El Paso County PCD File No. XXX-XX-XXX

Revise to
PPR-21-033

Final Drainage Report
Gateway Trucking, LLC

PROPOSED DRAINAGE MAP
GATEWAY TRUCKING
JOB NO. 25215.00
4/13/21
SHEET 2 OF 2

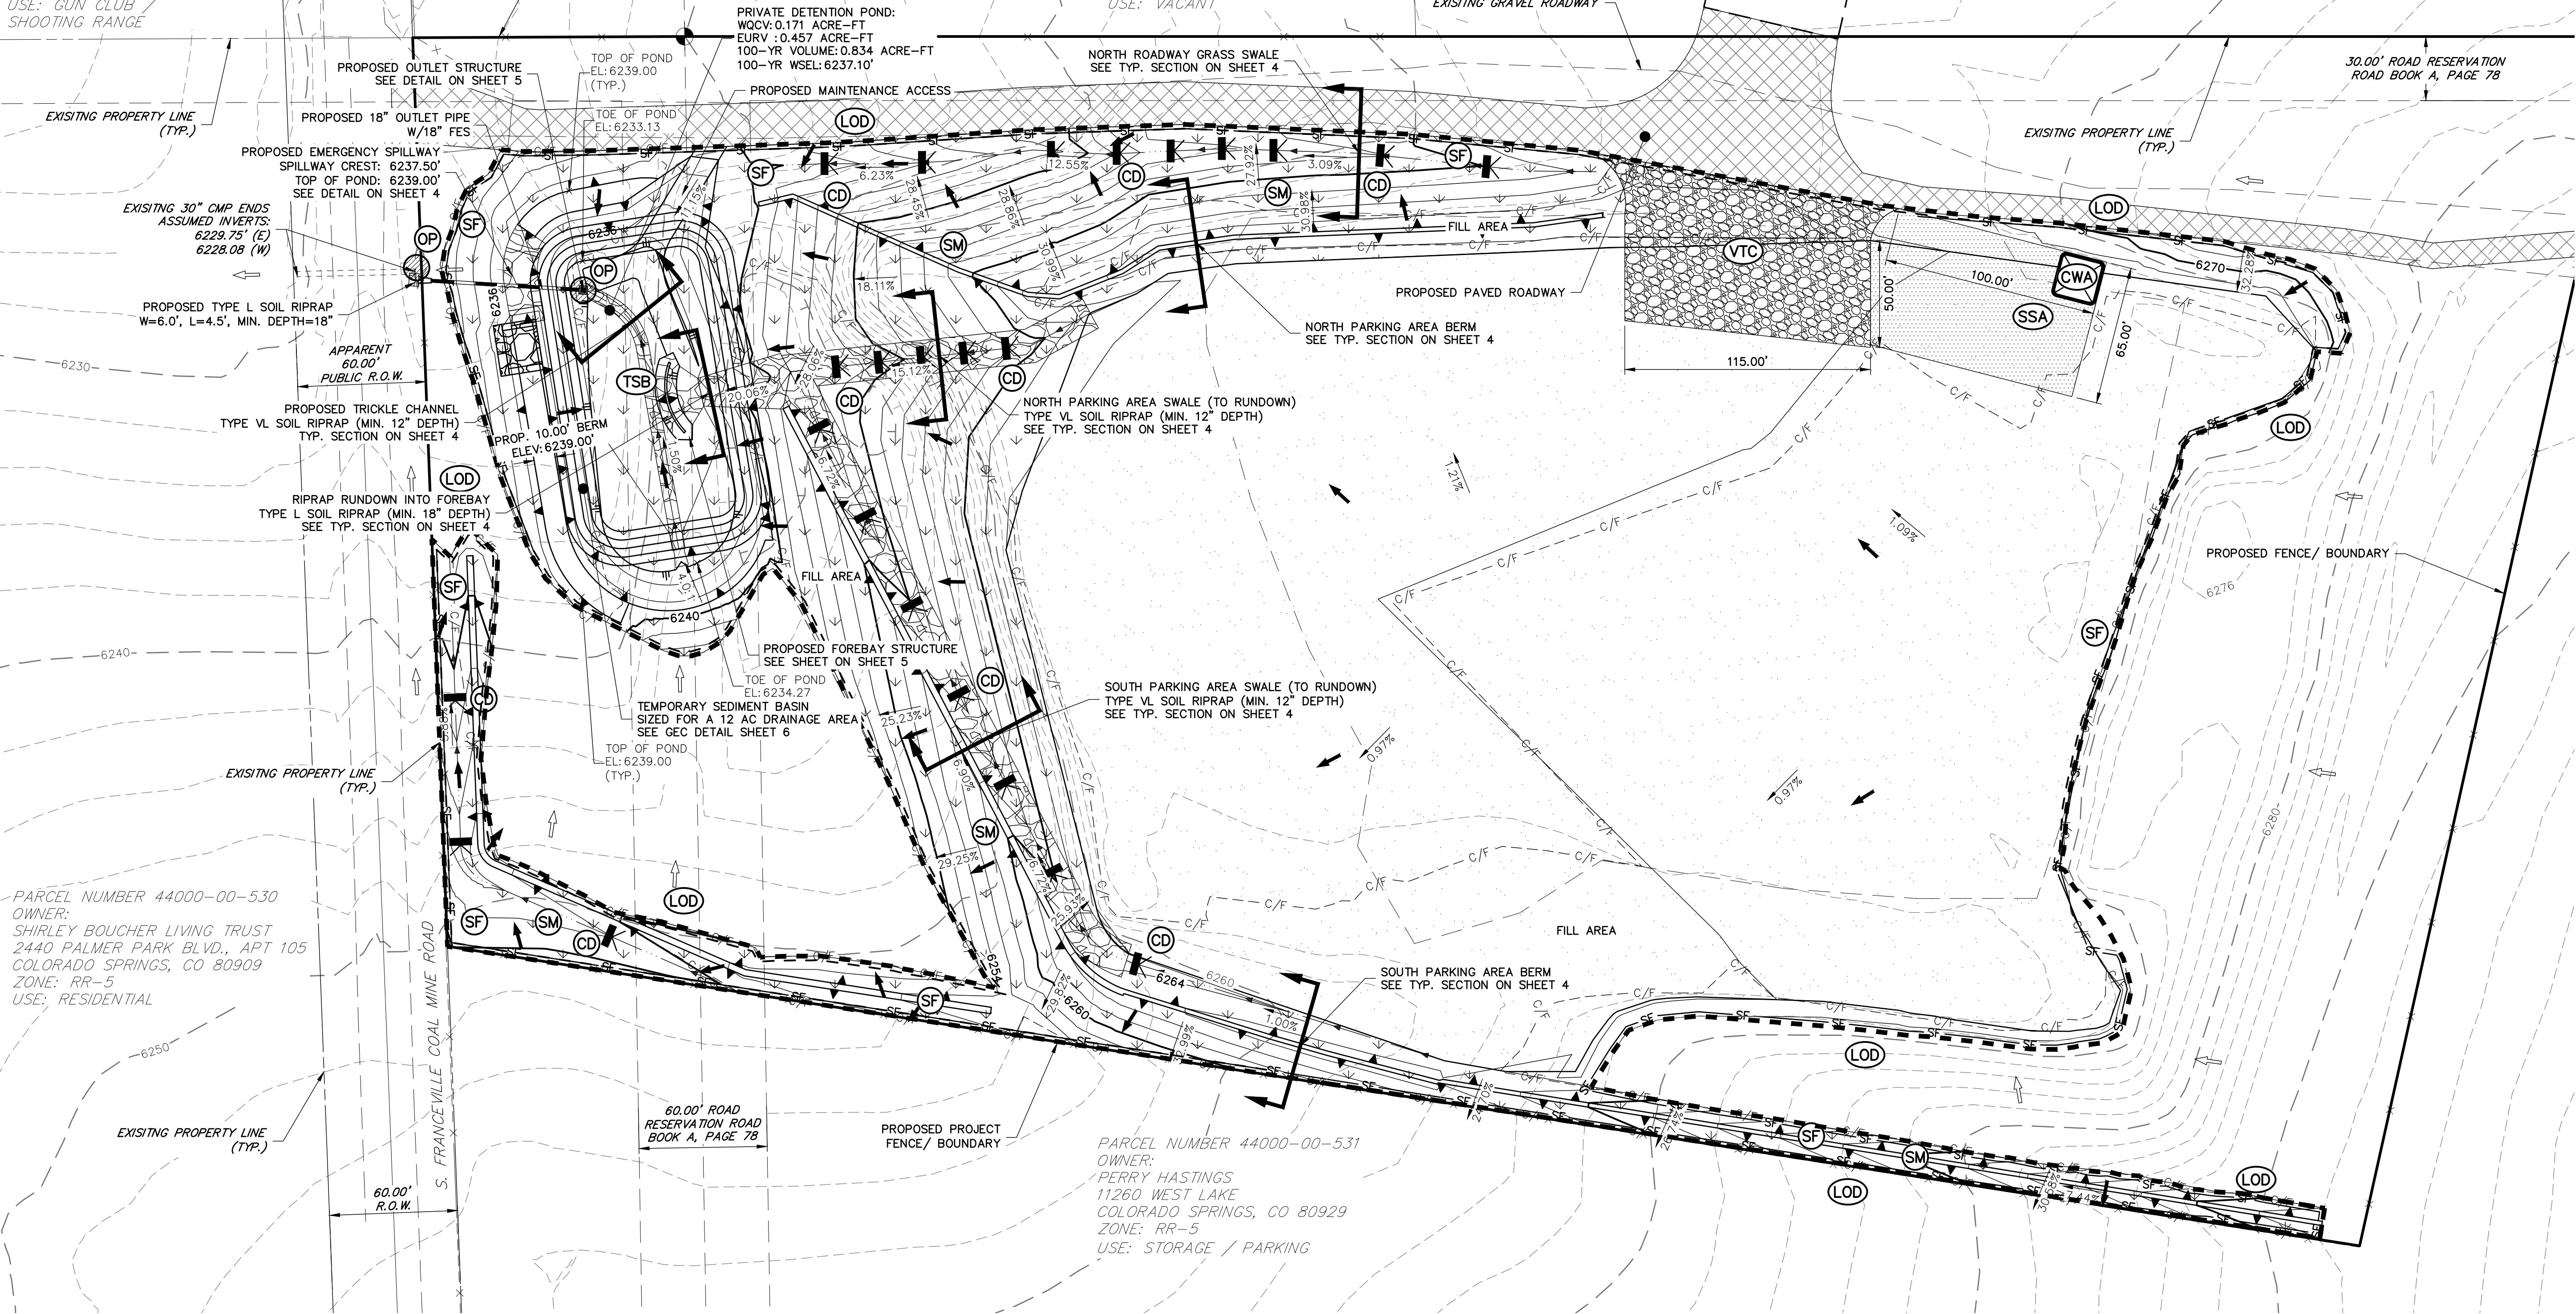
See ECM Appendix F Detail SD. 3-14 for the standard driveway access on Rural Roadway.

Provide calculation for the existing 30' CMP and provide a summary of your findings specifically in regards to Suitable Outfall (See ECM 3.2.4). Is this hydraulically adequate?

GATEWAY TRUCKING SITE
DEVELOPMENT PLAN
GRADING AND EROSION
CONTROL PLAN

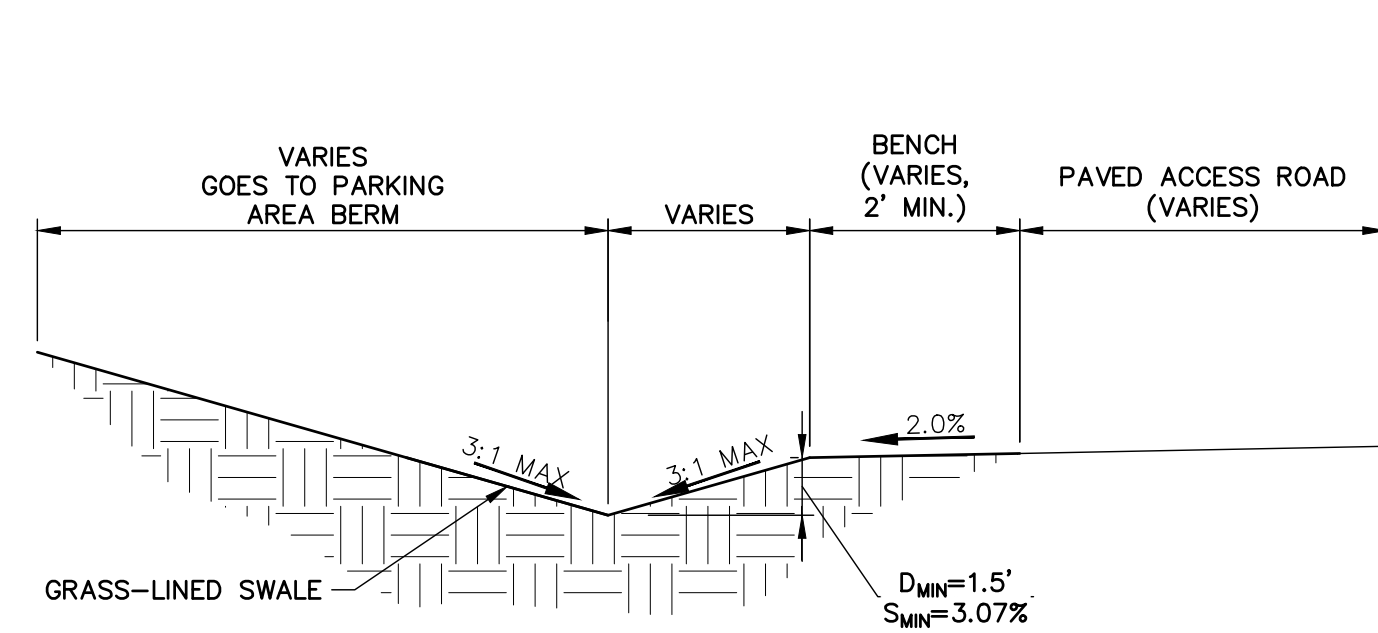
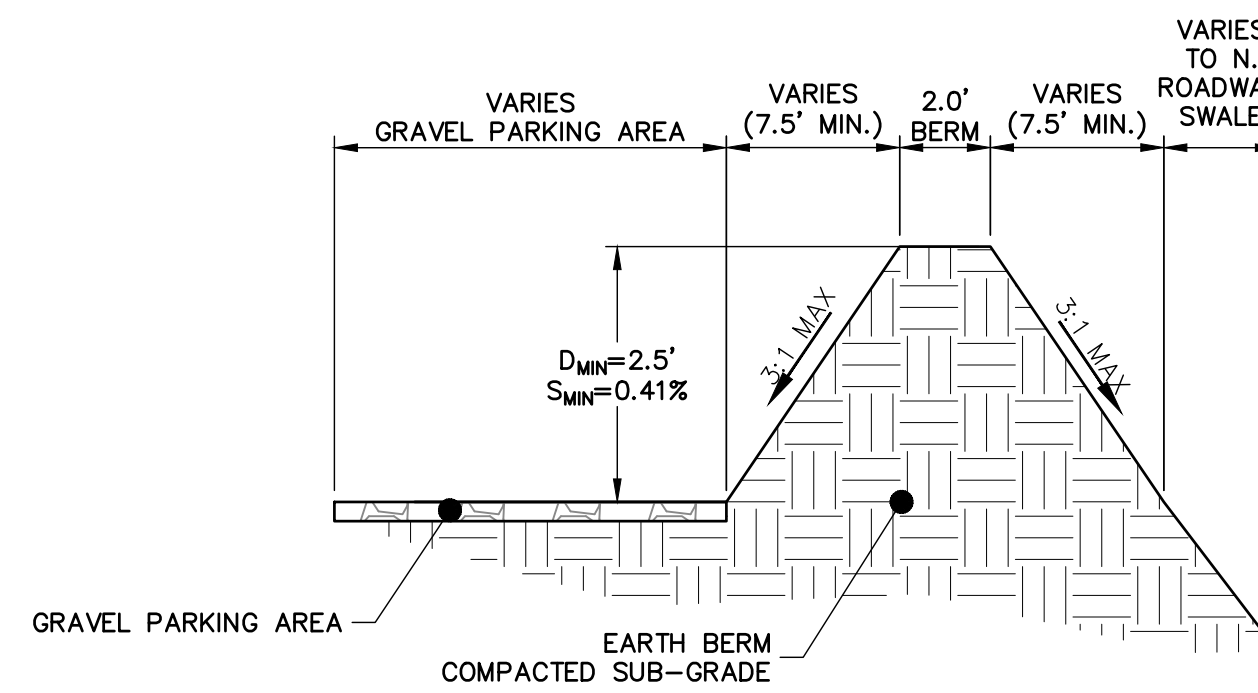
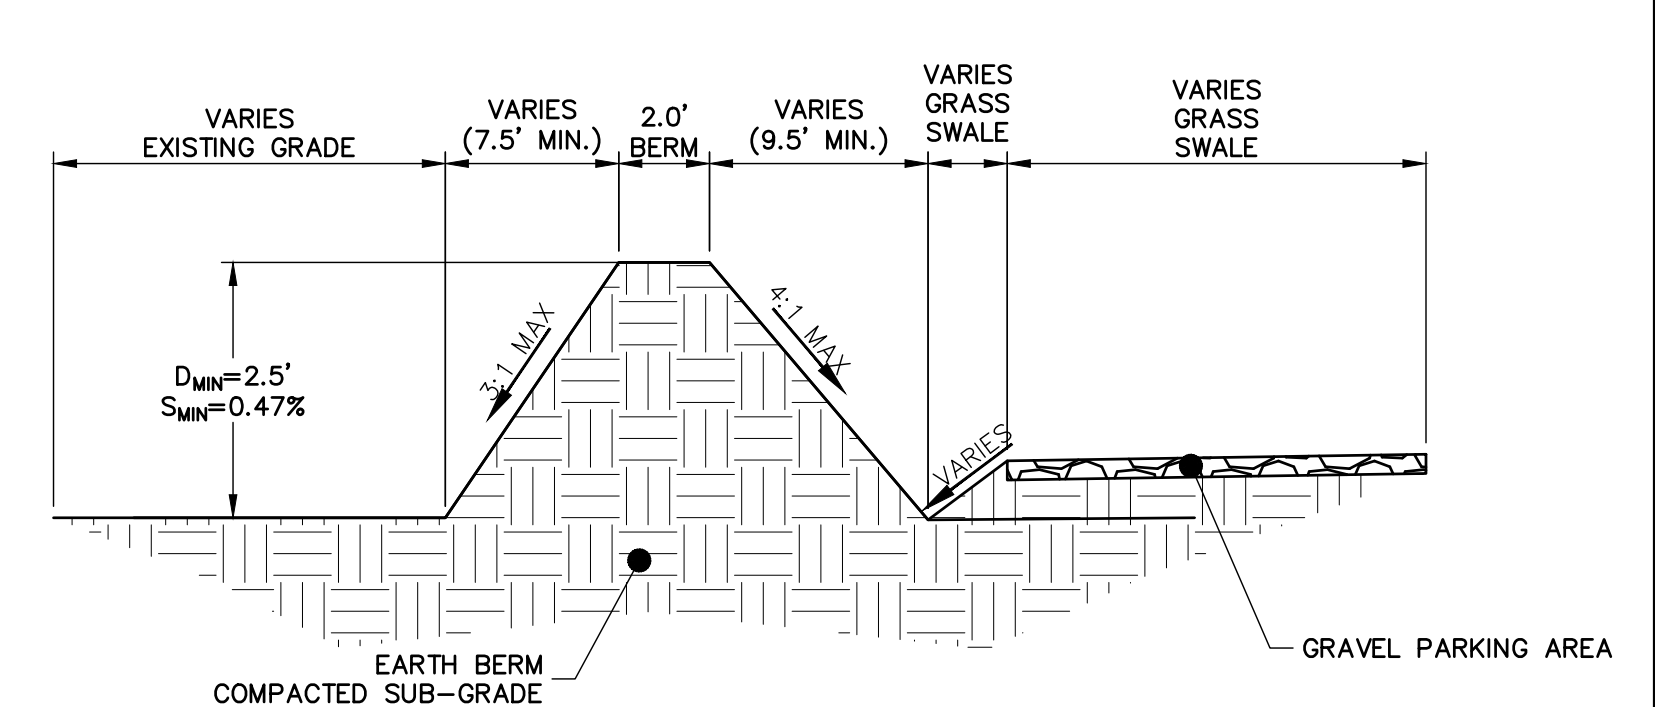
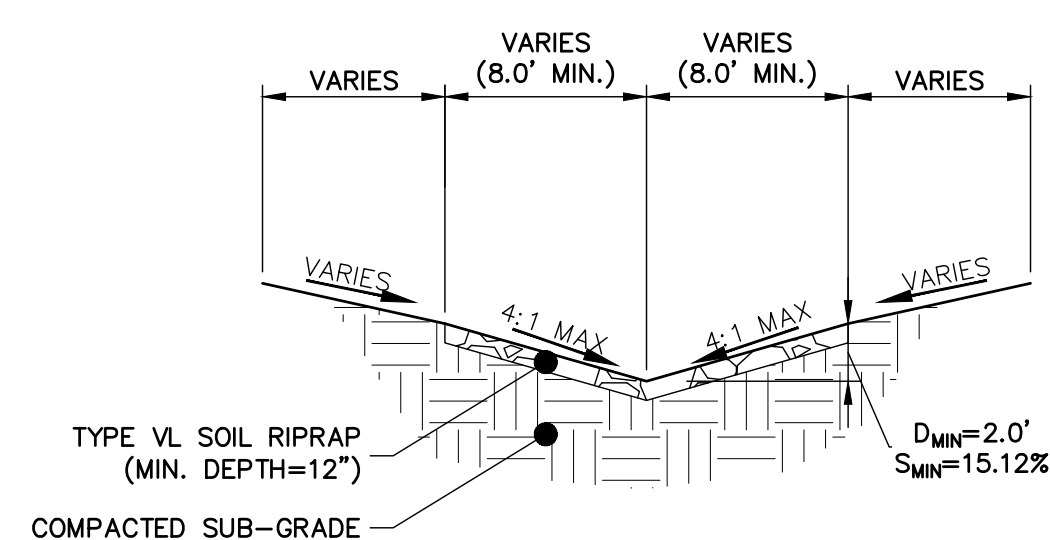
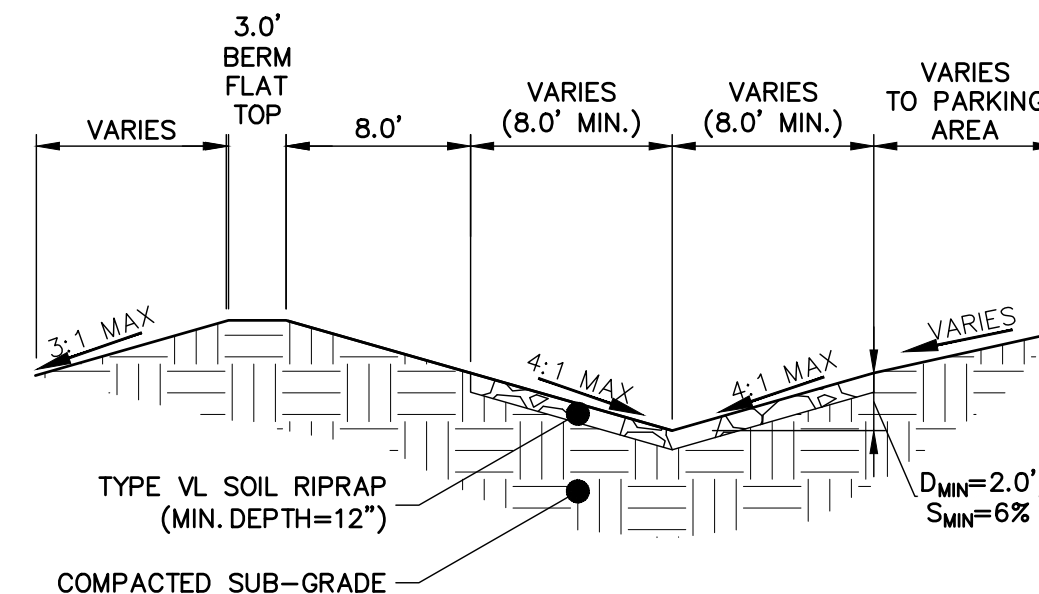
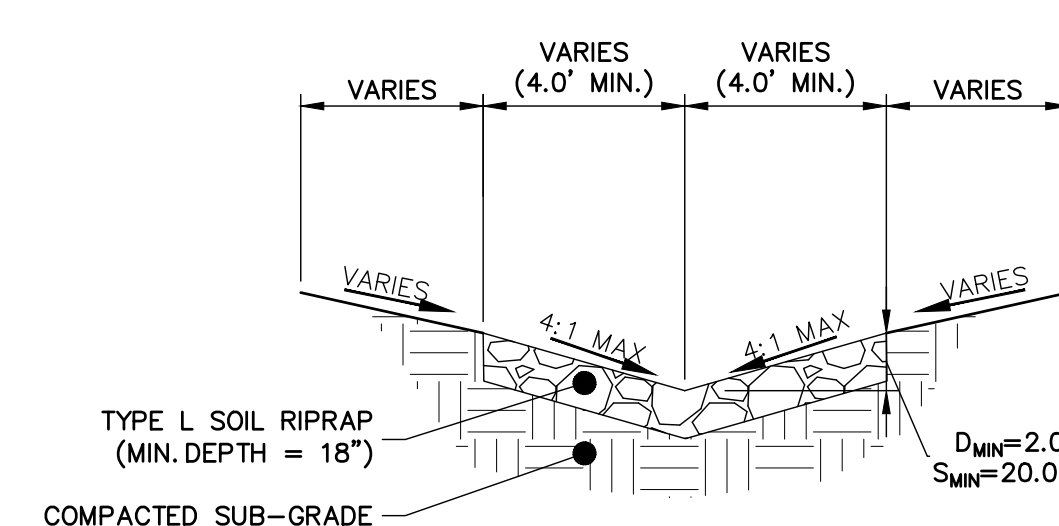
Remove this sheet from the drainage report.
